**Re: Former Signal Bulk Plant  
2001 Versailles Avenue, Alameda, CA**

Subject: Alameda County Comments to Drilling Workplan  
Alameda Bulk Plant, 2001 Versailles Avenue, Alameda

**PROPOSED BORING LOCATIONS**  
FORMER CHEVRON ALAMEDA BULK PLANT  
201 VERSAILLES AVENUE  
ALAMEDA, CALIFORNIA

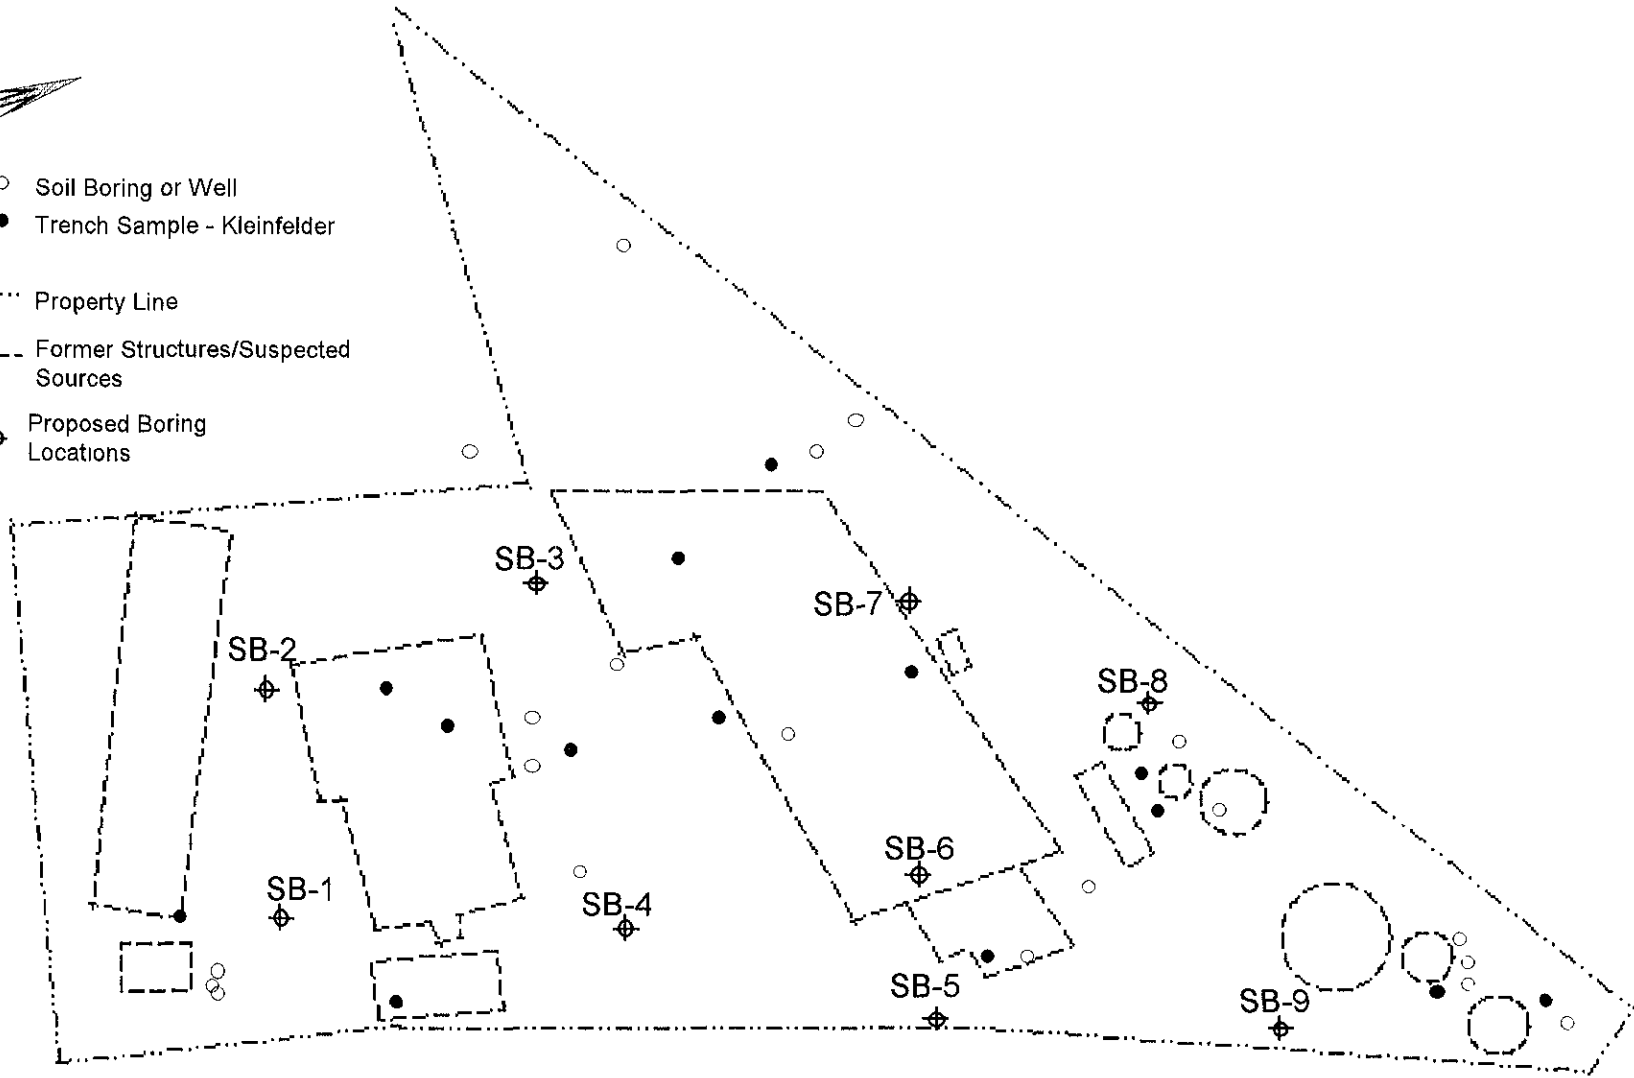
Item 1 Mr. Chan mentioned that Method 8010 need not be run on samples collected from Boring Number 2 (Figure 1), stating that solvents were not detected in Kleinfelder Trench Sample 47708-11. We are pleased to hear that ACHCSA is not concerned about solvents in this area. Please note, however, that sample 47708-11 is approximately 45 feet north of proposed Boring Number 2. The rigorous sampling proposed for this boring is to exclude the western portion of the site from any active remediation. We recommend that Chevron collect the most complete data at this point to avoid any ambiguity.

Item 2. Mr. Chan noted that Boring Number 6 is near Kleinfelder Trench 8, sample 47703. Boring Number 6 is proposed to characterize manifold lines (shallow contamination). The Method 8270 result redundancy that Mr. Chan refers to is from a sample collected at 7 feet below grade surface (bgs). We propose to collect one sample at 2.5 feet bgs and one at the water interface. If EPA Method 8270 results are found to be non-detectable, then confirmatory samples from excavation - when it occurs - need not be analyzed by this method.

Item 3: Mr. Chan appears to argue that Boring Number 7 is not necessary. The redundancy of Kleinfelder sample 47712 is noted, however, the possibility of commingled plumes exist in this area. Boring number 7 is placed to assess the possible extent of excavation in this area.

**SITE PLAN - POTENTIAL SOURCE AREAS**  
FORMER CHEVRON ALAMEDA BULK PLANT  
2001 VERSAILLES AVENUE  
ALAMEDA, CALIFORNIA

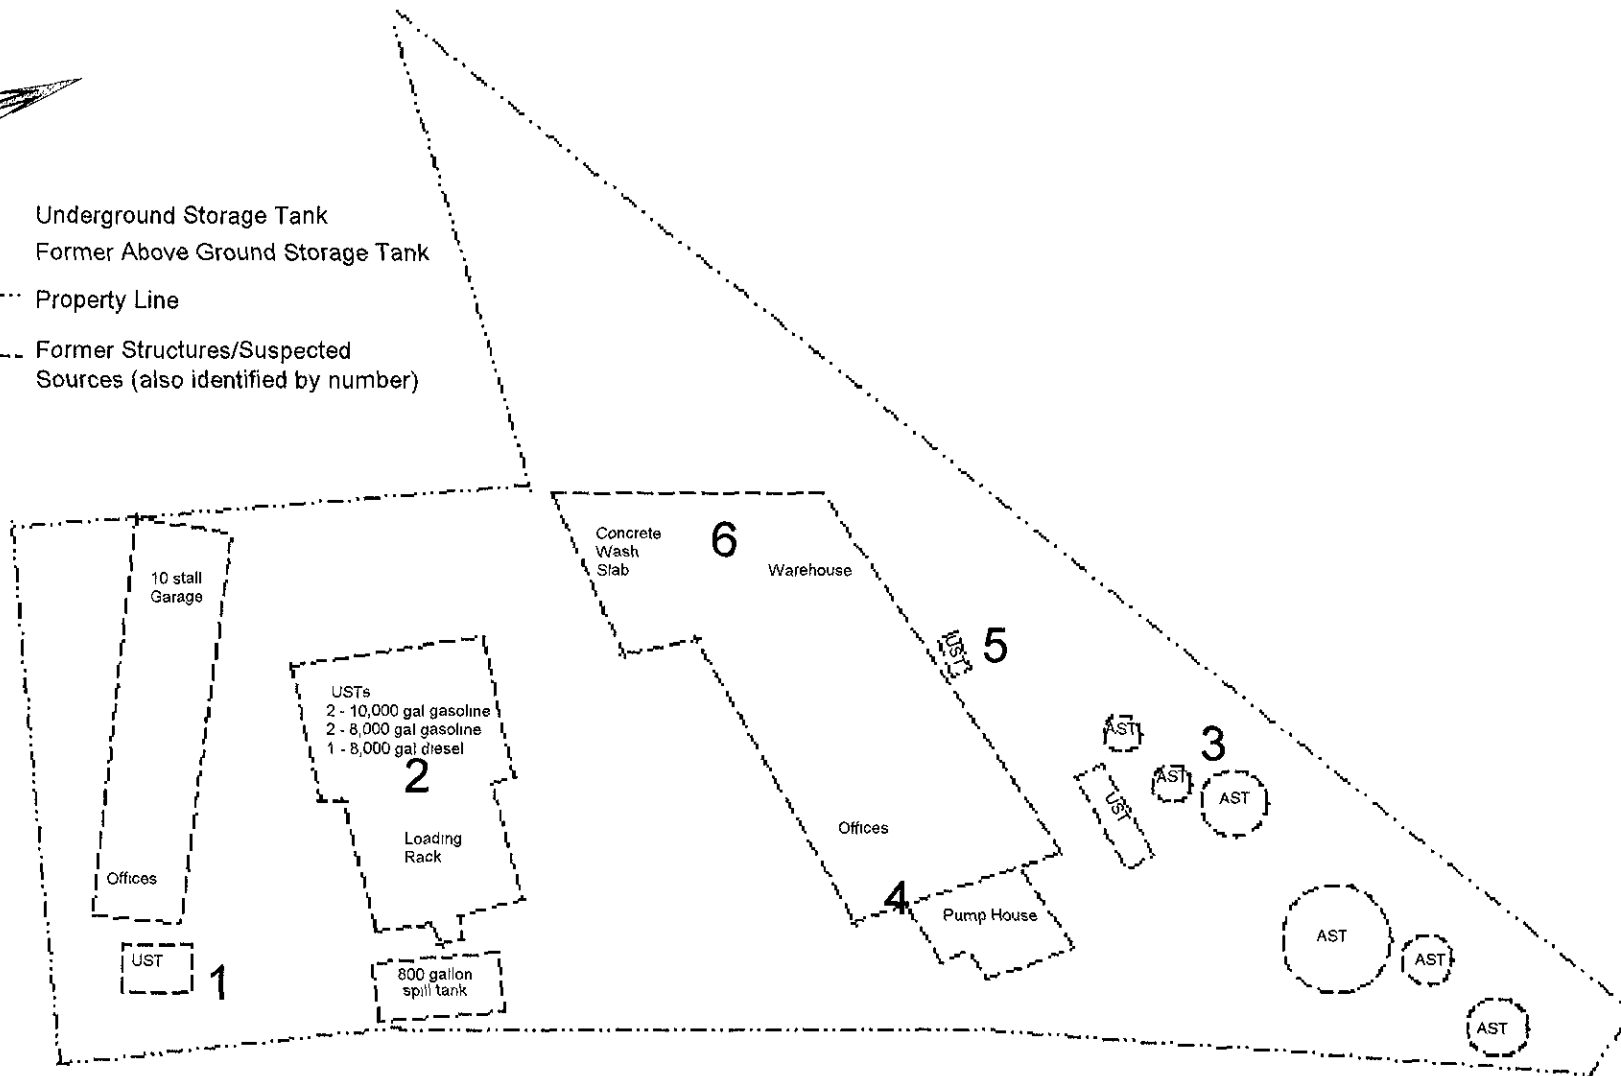
Item 5 The six identified source areas on-site are classified by Chevron (Figure 2) as

- \* The area at the corner of Fernside and Versailles Avenue, adjacent to a 1000 gallon underground storage tank (UST) still in place, and near Kleinfelder Trench Number 1.
- \* The former UST vault
- \* The above ground storage tank (AST) area on the north end of the site
- \* Three areas around the warehouse/office that likely are commingled plumes:
  - 1) manifold lines and sump
  - 2) oil receptacle
  - 3) warehouse and drum disposal area
